CROMER PLACE SUBDIVISION

Revised for the January 5, 2012 meeting:

APPLICATION NUMBER 3 DATE January 5, 2012

DETAIL SITE PLAN

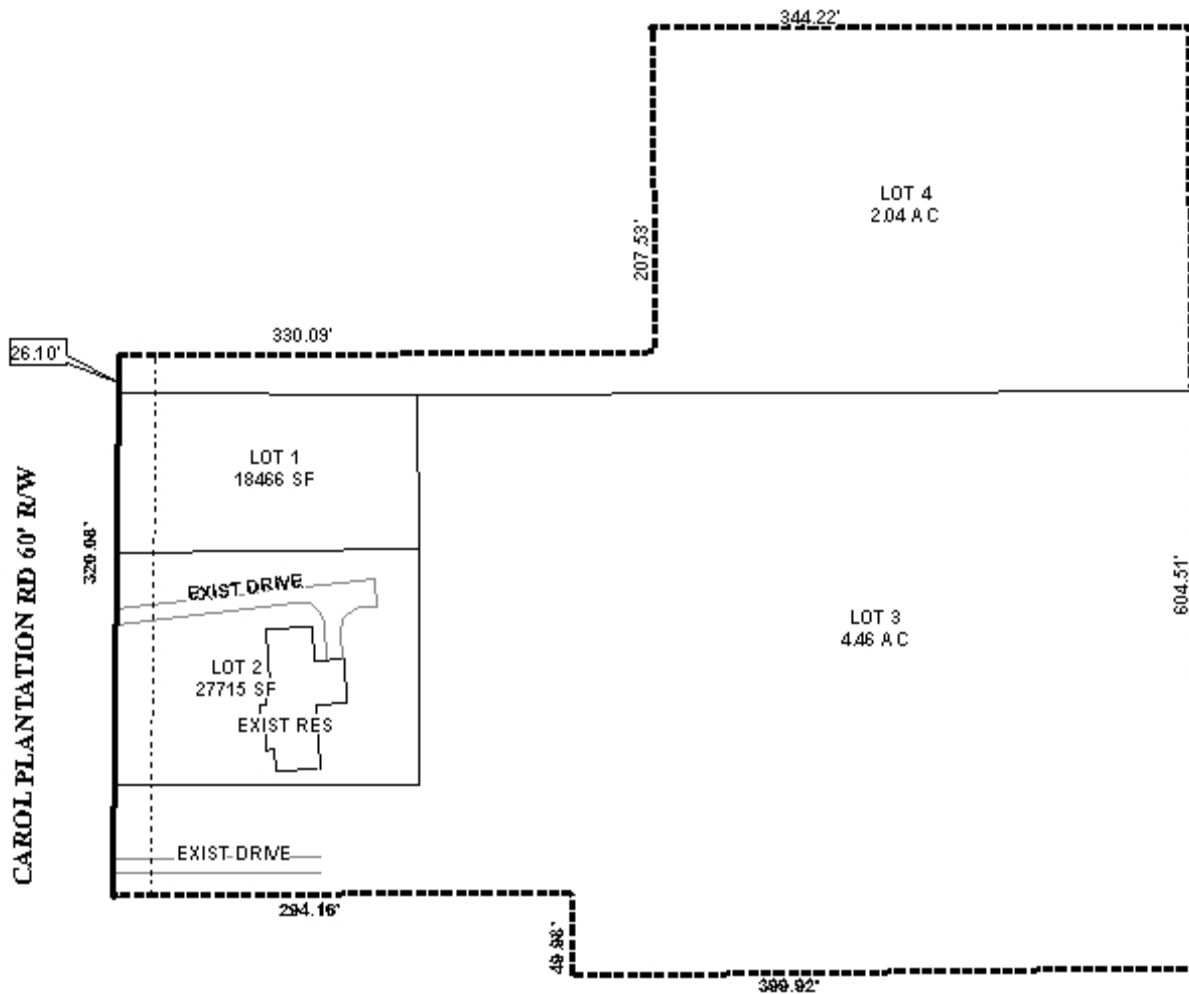
The applicant has submitted a revised application and preliminary plat to include Lot 2, Cromer Estates in the subdivision as well as new mailing labels and notification fees. As mentioned previously, the prior approval of the Cromer Estates Subdivision limited the currently proposed Lots 1 and 4 to a shared curb-cut because both lots were flag lots at the time of approval. Because Lot 1 is being proposed to have 100’ of frontage along Carol Plantation Road instead of its former 25’ of frontage, it may be appropriate to allow each lot to have its own separate curb-cut to Carol Plantation Road.

It should be noted that the proposed Lot 4 is still a flag lot with 26'± of frontage along Carol Plantation Road; however, the Planning Commission's prior approval of the lot would make the waiver of V.D.1. appropriate.

Based on the preceding, the application is recommended for tentative approval, with a waiver of Sections V.D.1. and V.D.3. of the Subdivision Regulations, subject to the following conditions:

- 1) depiction of the 25-foot minimum building setback line from Carol Plantation Road, as required by Section V.D.9. of the Subdivision Regulations;*
- 2) labeling of the lot sizes, in square feet and acres, or provision of a table on the Final Plat with the same information;*

- 3) placement of a note on the Final Plat stating that any lots which are developed commercially and adjoin residentially developed property must provide a buffer, in compliance with Section V.A.8. of the Subdivision Regulations;*

- 4) placement of a note on the Final Plat stating the site must comply with the City of Mobile storm water and flood control ordinances: (Must comply with the Mobile County Flood Damage Prevention Ordinance. Development shall be designed to comply with the storm water detention and drainage facility requirements of the City of Mobile storm water and flood control ordinances, and requiring submission of certification from a licensed engineer certifying that the design complies with the storm water detention and drainage facility requirements of the City of Mobile storm water and flood control ordinances prior to the issuance of any permits.);*

- 5) placement of a note on the Final Plat limiting all lots to one curb cut each to Carol Plantation Road, with the size, design, and location of all curb-cuts to be approved by Mobile County Engineering and conform to AASHTO standards; and*

- 6) placement of a note on the Final Plat stating that approval of all applicable federal, state, and local agencies is required for endangered, threatened, or otherwise protected species, if any, prior to the issuance of any permits or land disturbance activities.*
